MOD2019/0595

Project: SECTIONS 4.55 - PROPOSED ALTERATIONS AND ADDITIONS

1/2 DARLEY ST - EAST MONA VALE

Dwg No. DA 10 B

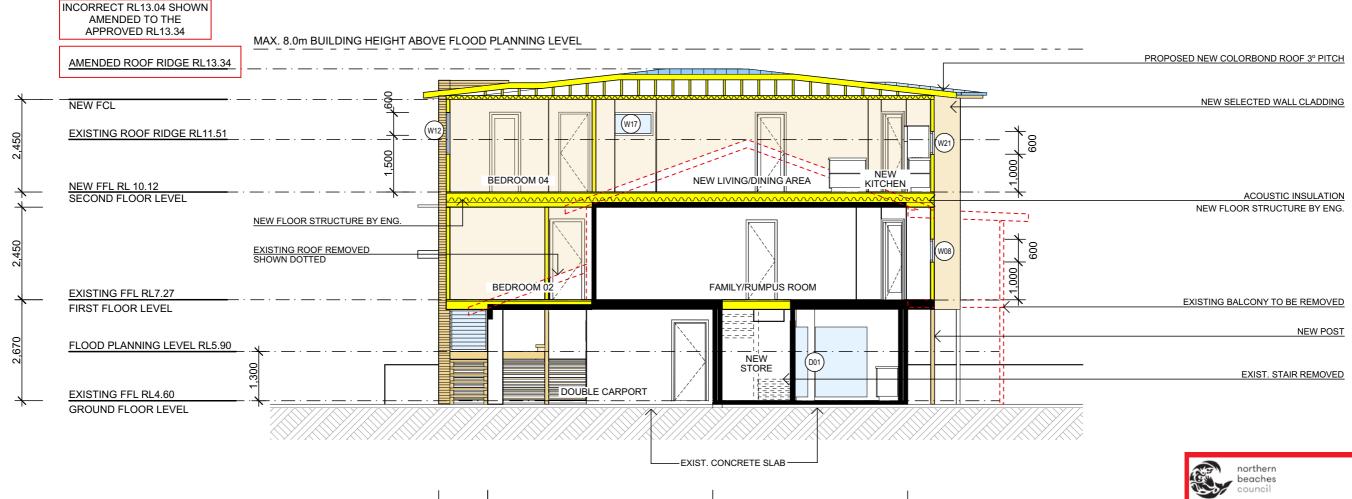
* All workmanship & materials shall be in accordance with the require current editions including amendments of the relevant SAA Codes of Practice. the Building Code of Australia and local council requirements.
- New materials are to be used throughout unless otherwise noted * Concrete footings, slab, structural beams or any other structural members are to be designed by a practicing engineer.
- REV: DATE: DESCRIPTION: 12/11/2019 CORRECT ROOF RIDGE RL13.34
